Subject: AIR BAG WARNING WITH DTC B1126:13 OR B1127:13	Bulletin No.: 08-002/22
	Last Issued : 04/22/2022

2020-2022 CX-30

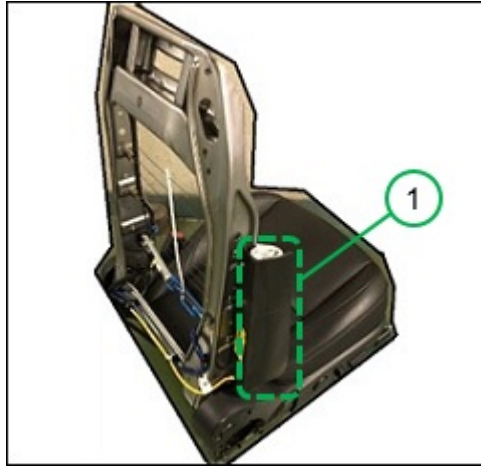
Some vehicles may exhibit that the air bag warning light turns on or repeats cycles of turning on and off with DTC B1126:13 and/or B1127:13 stored in memory.

- When the driver or passenger moves, a load is applied to the seat back and the load may cause displacement of the mating terminals in the side air bag module connector, resulting in insufficient contact and higher resistance.
- The DTC detection level is too sensitive.

- The design of the connector terminals in the side air bag module has been modified for firmer contact.
- The DTC detection level of the SAS control module has been optimized.

1. Verify the customer concern.
2. **[For vehicles with VINs lower than 3MVDM*****414338 (produced before Feb. 27, 2022)]** Replace the affected side of the side air bag module(s) (1) with modified one(s) according to instructions on MGSS.
 - US/Canada spec: (SIDE AIR BAG MODULE REMOVAL/INSTALLATION [TWO-STEP DEPLOYMENT CONTROL SYSTEM - US/CANADA SPEC.])
 - Mexico spec: (SIDE AIR BAG MODULE REMOVAL/INSTALLATION [STANDARD DEPLOYMENT CONTROL SYSTEM - MEXICO SPEC.]
